CERTIFICATE OF APPROPRIATENESS

Property: 501 Highland Street, lot 16, block 9, Woodland Heights Subdivision. The property includes a historic 1,654 square foot two story residence and two story garage-apartment situated on a 5,000 square foot (50' x 100') corner lot.

Proposal: Alteration – Addition *Revision*

INSPECTOR PHOTOS

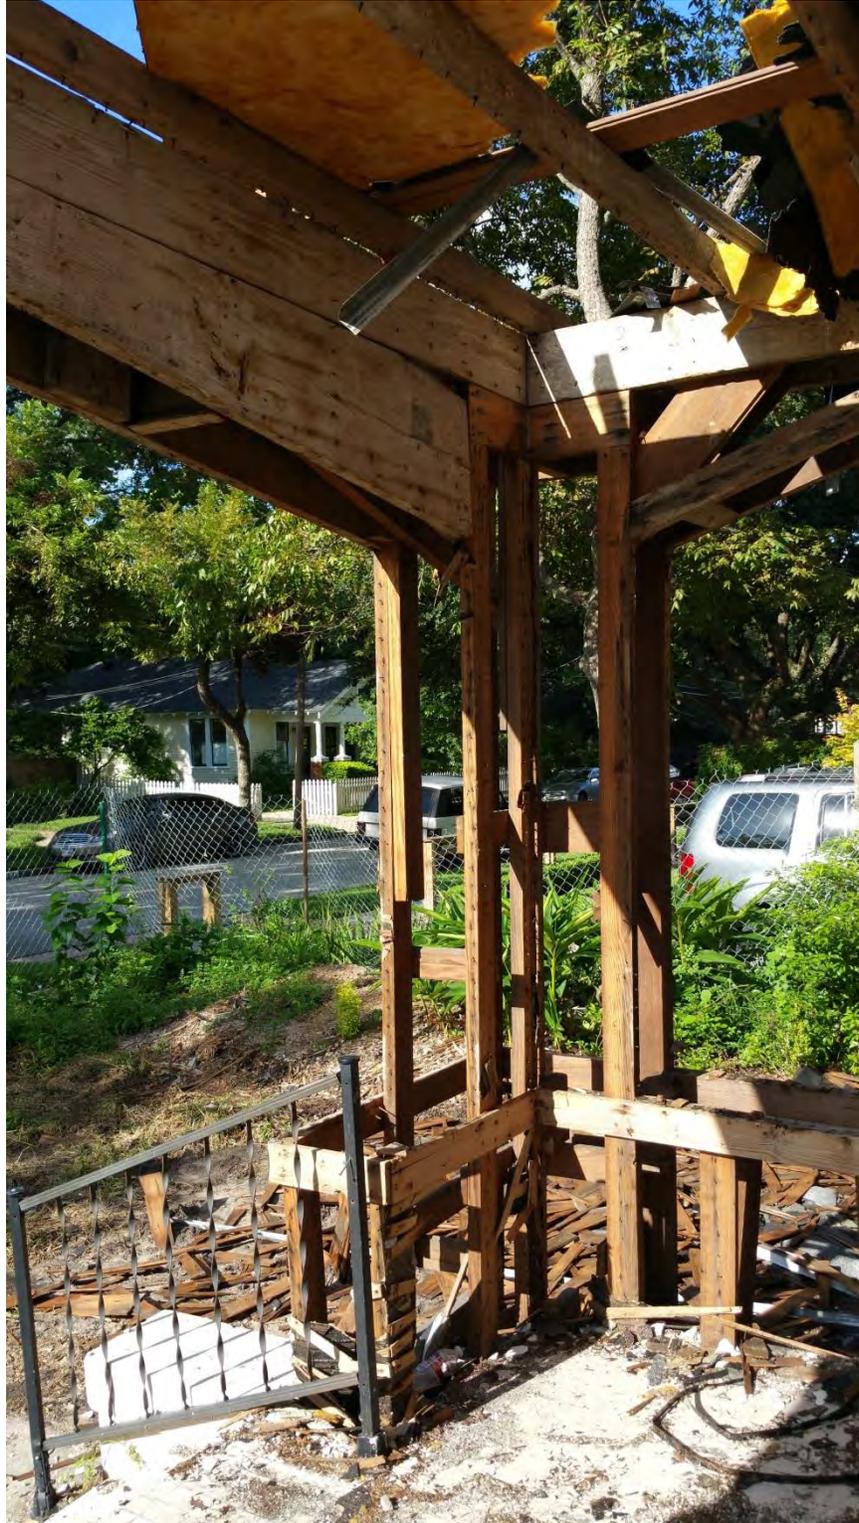
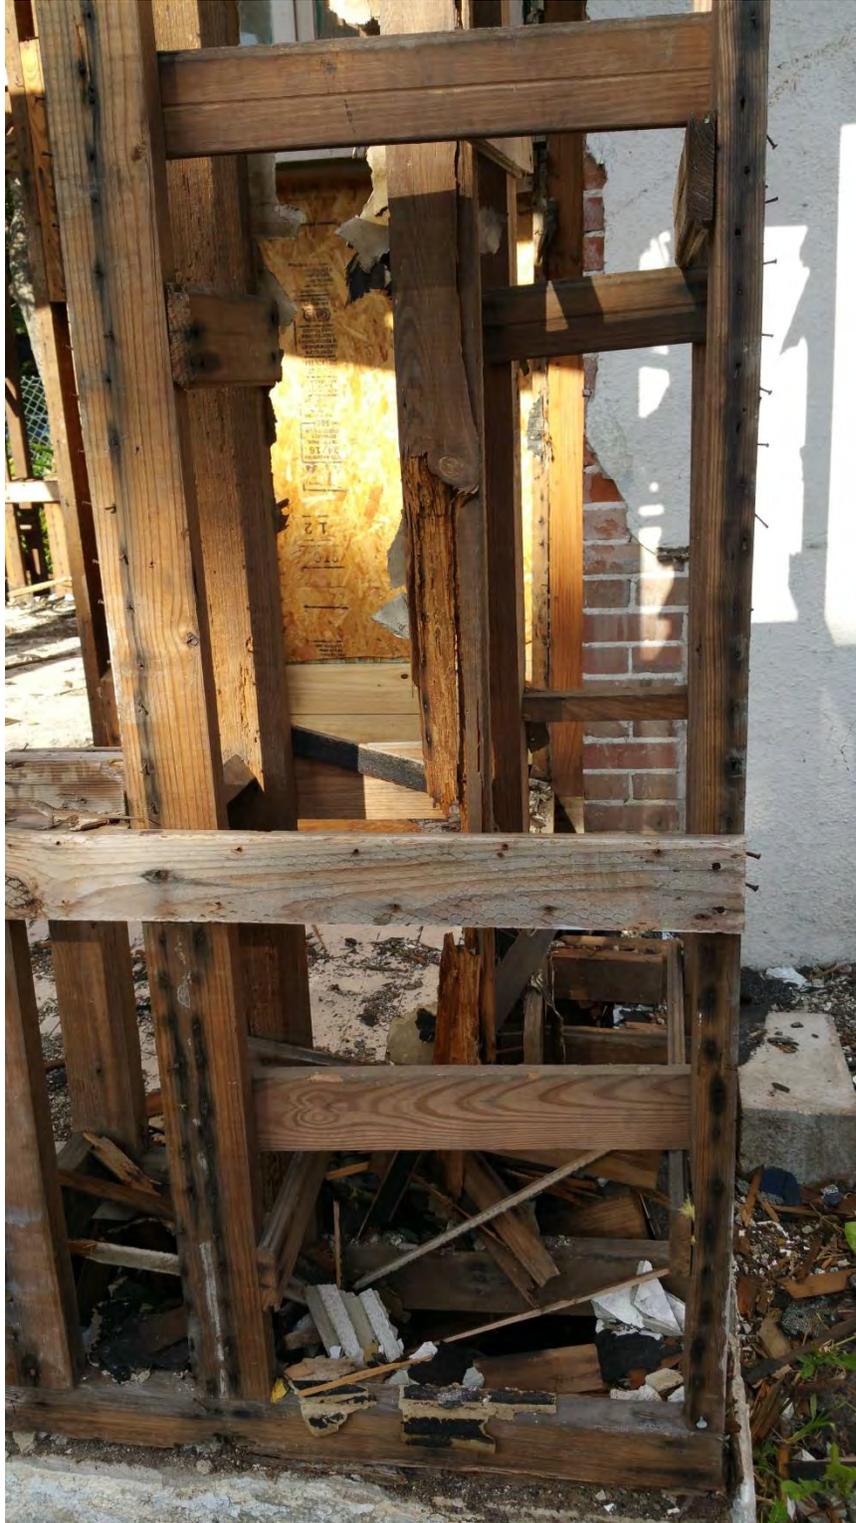
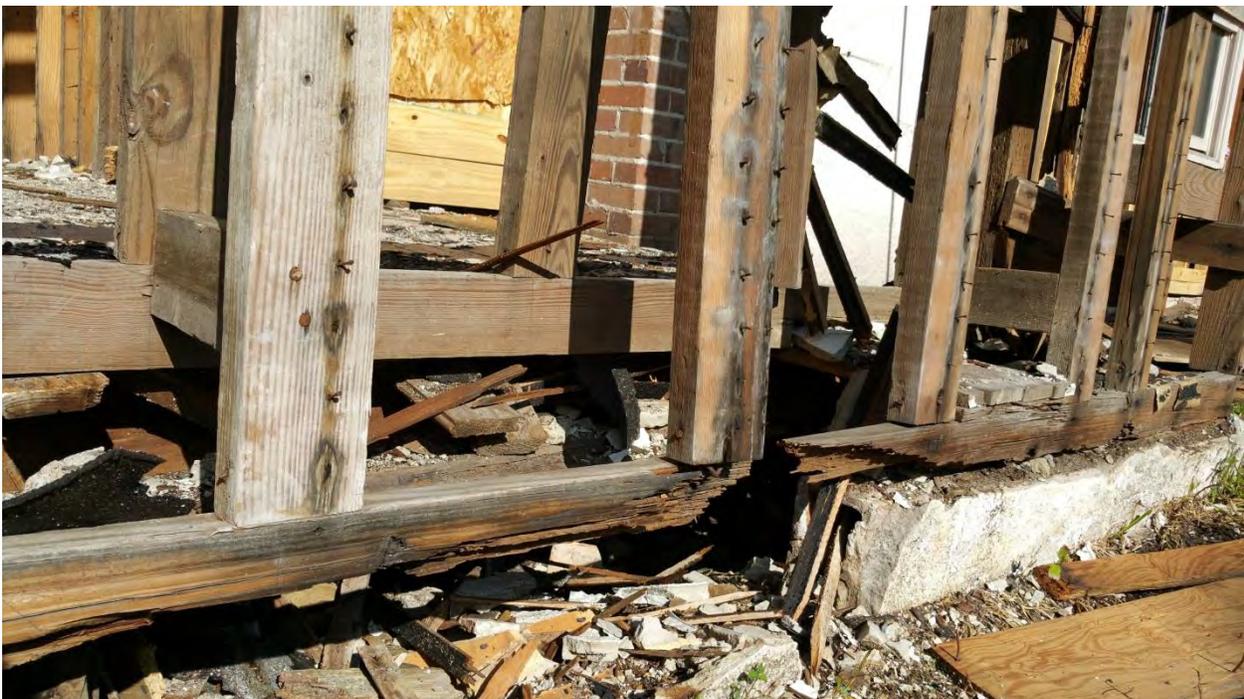
During construction, the front porch was removed while the residence was being lifted to install the foundation. City Inspector photos taken of the porch prior to the house being lifted show that the structural material underneath the stucco cladding had incurred termite and rot damage. In addition, newer lumber had been added to support and replace sections of the deteriorated old growth material.

During construction, the contractor removed the existing stucco cladding discovered that the porch structure was deteriorated to the point where lifting it with the residence would not be possible. In addition, evidence that the porch was repaired with newer lumber became apparent.

The City Structural Inspector took several pictures of the structural material. Shortly thereafter, the builder removed it. The original wood arches were retained. The damaged and non-historic structural material was discarded.

The applicant is now requesting approval to replace their previously existing front porch. The porch will be identical to the one removed. The applicant has salvaged portions of the historic old growth arches and proposes to incorporate them in the new porch.

Staff and the City Structural Inspector noticed this and placed a stop work order on the project. The builder is now applying for a COA to reconstruct the porch to its original dimensions. The original structural material that was retained will be reused.
